Detailed Site Plan Melford Property, Pod 6

DSP-07031-04

STAFF REPORT

SUBJECT: Detailed Site Plan DSP-07031-04
Type II Tree Conservation Plan TCPII-036-99-16
Melford Property, Pod 6

Figure 2: Proposed Freestanding Signs

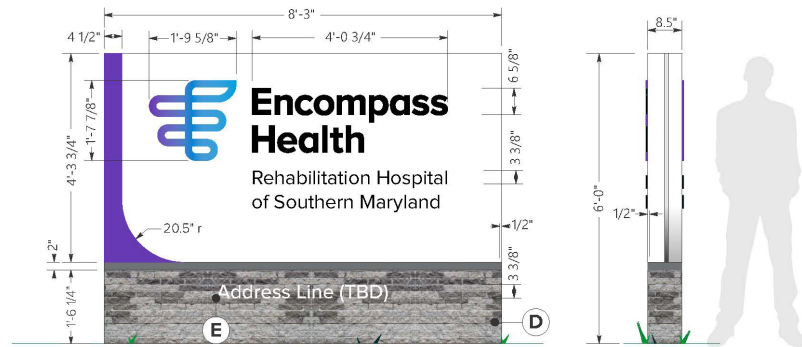
The DSP proposes 6-foot-high, double-faced, free-standing signs at each entrance to the facility from Melford Boulevard, and one, back-lit, building-mounted sign above the primary entrance to the building. The freestanding signs include 8-foot-wide aluminum cabinets that are mounted on a dark gray masonry base matching the architecture of the building. The signs include the logo and channel letters displaying the name of the rehabilitation center. It

is noted that the freestanding signs do not include landscaping at their base and have been conditioned herein to be added to provide seasonal interest.

- c. Provide a Tree Canopy Coverage Schedule showing conformance to the Tree Canopy Coverage Ordinance, or a note regarding the applicable exemption.
 - d. Provide landscaping at the base of the freestanding signs to provide seasonal interest.

Figure 3: Proposed Building Mounted Sign

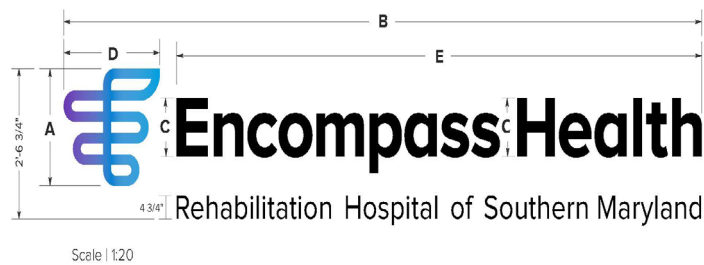
- (3) Provide building-mounted lighting to illuminate the gazebo/therapy courtyard area.
 - n. Provide additional information regarding how on-site signage will be illuminated and note that illumination by spotlights is prohibited by the City of Bowie.
